BOSTON REGION METROPOLITAN PLANNING ORGANIZATION

DATE April 3, 2014
TO Boston Region Metropolitan Planning Organization (MPO)
FROM William Kuttner, MPO Staff
RE A Preferential Lane on I-93 North: A Conceptual Plan

Comment Letter from I-93/I-95 Interchange Consulting Engineers

Date: March 5, 2014
To: Ed Hollingshead
From: Rick Azzalina
Re: A Preferential Lane on I-93 North: A Conceptual Plan
FST Review Comments

FIGURE 7
Narrow Corridor
Entry-Exit Section

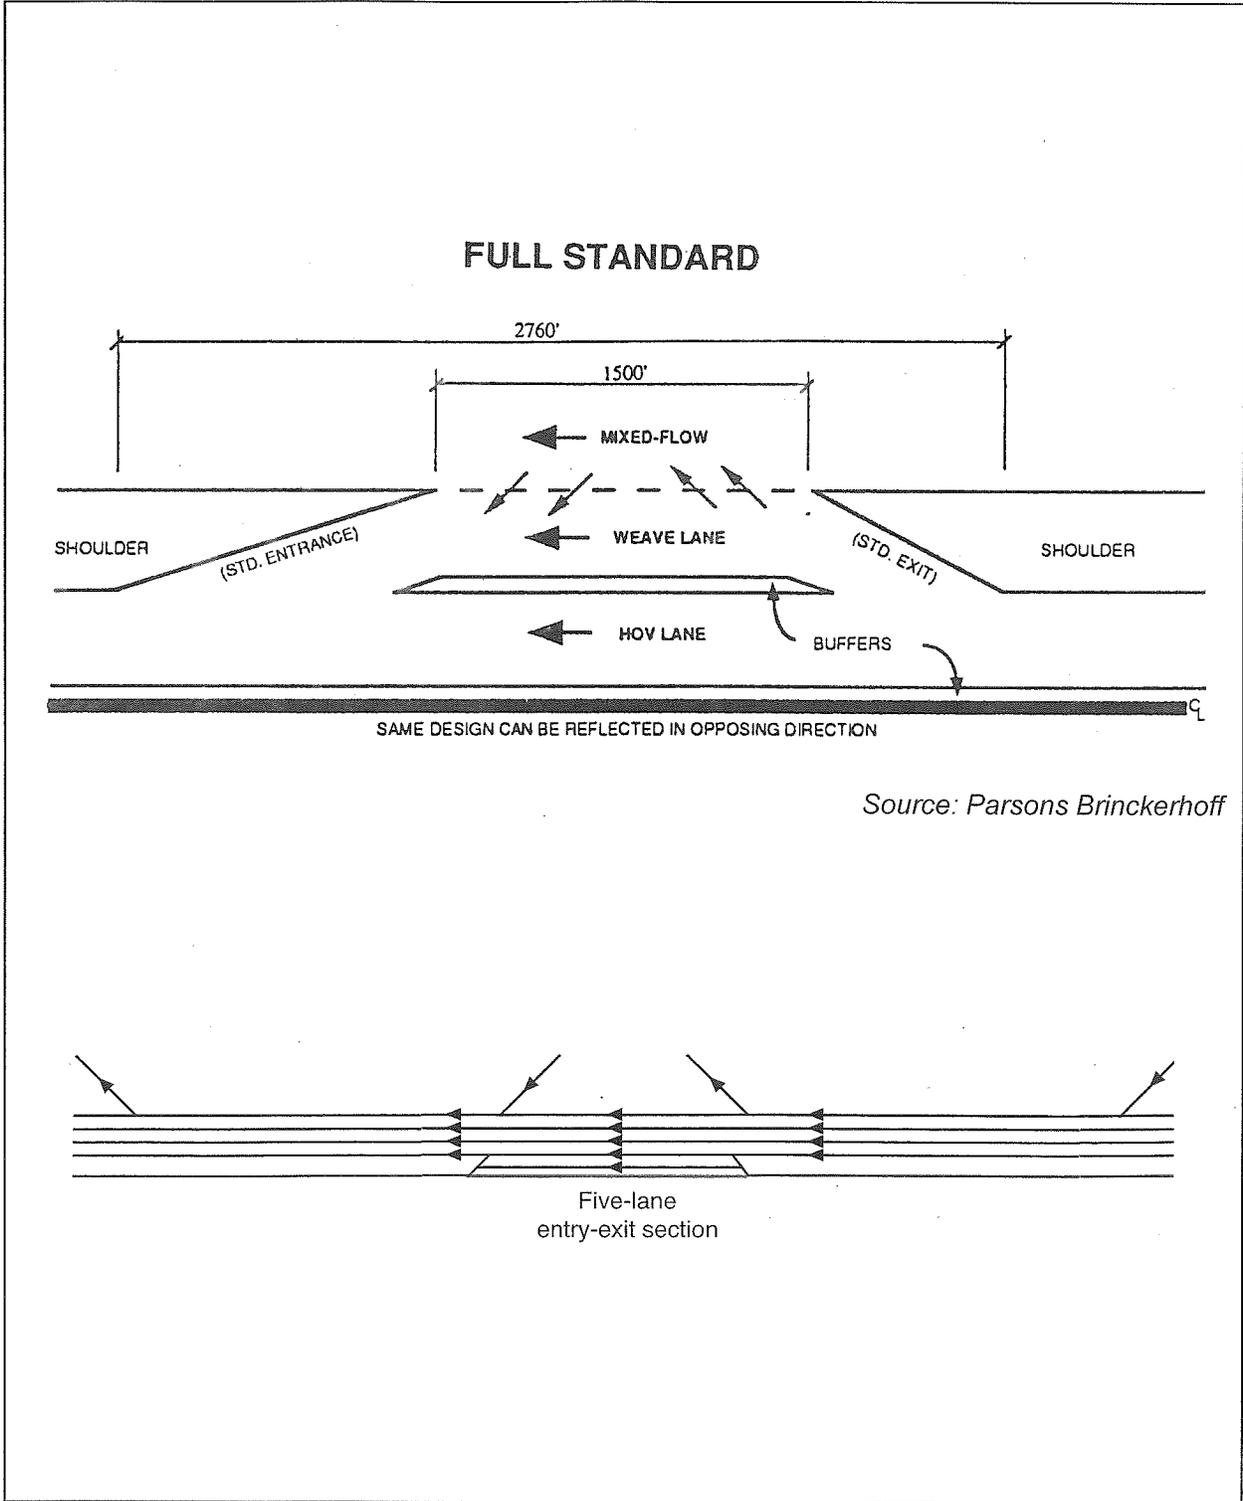
18. On Page 39 it states *“Design guidelines recommend that the parallel general-purpose and preferential lanes allow a distance of between 1,000 and 1,500 feet in which vehicles can enter or exit the preferential lane system.”* Due to the significant traffic volumes along the I-93 corridor in both the AM and PM peak periods we would suggest using 1,500 feet as the design length of entry-exit sections and, to minimize right of way impacts, applying this length to the configuration shown on Figure 7 on Page 40 where weaving takes place in the adjacent general purpose lane.
